Service Bulletin

Bulletin No.: PIT5689N

PRELIMINARY INFORMATION

Subject: No Restart after an Auto Stop Event / No Crank / Dead Battery / Glow Plug / Transfer Case / SES MIL / DTC

Shown above is ground G132 loose.

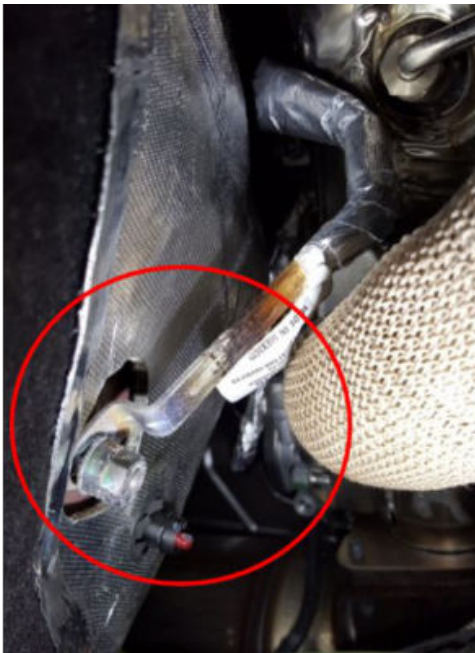
Involved Region or Country	North America, Europe, Australia & New Zealand
Condition	<p>Some customers may comment of the following:</p> <ul style="list-style-type: none"> - After an auto-stop event the engine does not restart (if equipped). - No crank (may be intermittent) - Dead Battery - Transfer Case Range Actuator Learn Failed - SES MIL with any of the following DTCs: P0562, P0615, P0617, P0621 P0622, P0700, P1005, P26E4, P26E5, P26E6, P305D, P305E, P2796, U010E, U0102, U0106, U0284, U0285, U0672, U029D, U029E, U02A1, U02A3, U0623, U220E, U111A, U111E, U1348, U18DE, U3003, U3006, U3007, U0403, U0101, P066B, P066D, P066F, P067B, P067D, P068D, P068F, C15AC, C118D, P0671, P0672, P0673, P0674, P0675, P0676 P067F, P0677, and P0678
Cause	These concerns could be caused by a broken or loose engine ground cable/strap, which grounds the engine (2) to the body (1), as shown below.

Inspect the engine to body ground cable/strap, G132 and G134. Tighten any loose ground connections or replace any damaged ground cable/strap. Ensure that the ground cable/strap is properly orientated to prevent damage to the ground cable/strap caused by powertrain movement.
